Subject: WATER AND WASTEWATER CAPACITY AVAILABILITY LETTER 650 N Andrews Ave – DRC Case No. UDP-S23057 650 N Andrews Ave, Fort Lauderdale, FL 33311

City of Fort Lauderdale Public Works Department Water and Wastewater Capacity Analysis

650 N Andrews Ave – DRC Case No. UDP-S23057 650 N Andrews Ave, Fort Lauderdale, FL 33311

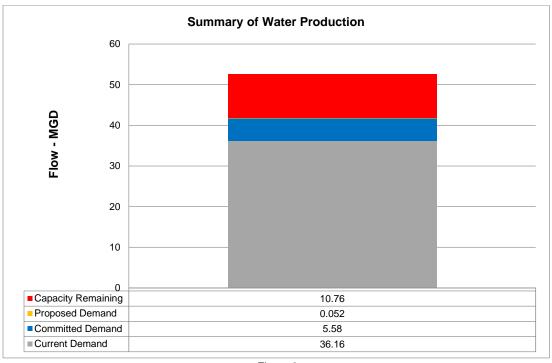
The current twelve-month rolling average production at the two plants is 36.16 MGD. The previously committed demand from development projects in the permitting or the construction stage is 5.58 MGD. Combining these figures with the demand from the proposed project of 0.0524 MGD, the required production would be 41.79 MGD. This is less than the allowable withdrawal limit of 52.55 MGD. Therefore, the water plants have sufficient capacity to serve this project. See Figure 3 below.

Recommended Water Infrastructure Improvements: No improvements required.

Figure 4

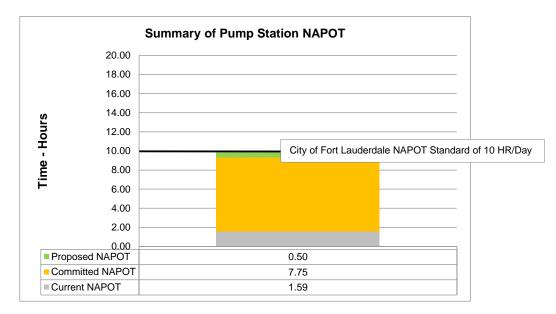
Evaluation of impact on pumping station: PS A-21 has a duty point of 1200 gallons per minute (GPM) and has a Nominal Average Pumping Operating Time (NAPOT) of approximately 3.17 hours per day. Based on projected sewage flows, the pumping run times would increase approximately 30 minutes per day. Additionally, there are other committed flows from proposed developments within the PS A-21 basin resulting in 464.88 minutes of additional runtime. PS A-21 will have a NAPOT of 11.42 hours once the proposed developments are complete, more than the recommended average of 10 hours per day. However, the current NAPOT of 11.42 reflects the entire A-21 Basin as it is today, prior to the rerouting of the flow to the newly constructed pump station A-24. It is anticipated that A-24 will receive 1/2 of the existing flows resulting in a current NAPOT of approximately 1.59 hours. This puts the projected NAPOT at 9.83 hours. The demand for this proposed development will not exceed the City's NAPOT standard of 10 hours for PS A-21. Therefore, PS A-21 can support the demand of this project. See Figure 4 below.

Figure 5

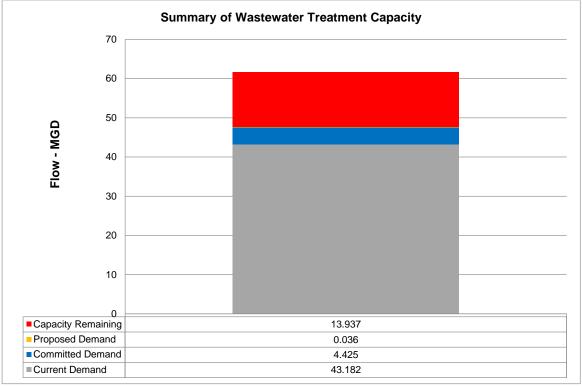
Evaluation of impact of Permitted Wastewater Plant Capacity: The City of Fort Lauderdale owns and operates the George T. Lohmeyer Regional Wastewater Treatment Plant (GTL), which provides wastewater treatment for the City of Fort Lauderdale. The Florida Department of Environmental Protection's (FDEP) permitted capacity for GTL is 61.58 MGD-TMADF (Million Gallons per Day – Three Month Average Daily Flow). The three-month average daily flow (TMADF) to the plant is 43.18 MGD. Combining the committed flows for previously approved projects of 4.43 MGD plus the 0.0361 MGD net contribution from the project results in a total projected flow of 47.64 MGD. This is less than the permitted treatment plant capacity of 61.58 MGD. Therefore, the treatment plant has sufficient capacity to serve this project. See Figure 5 below.

Recommended Wastewater Infrastructure Improvements: No improvements required.
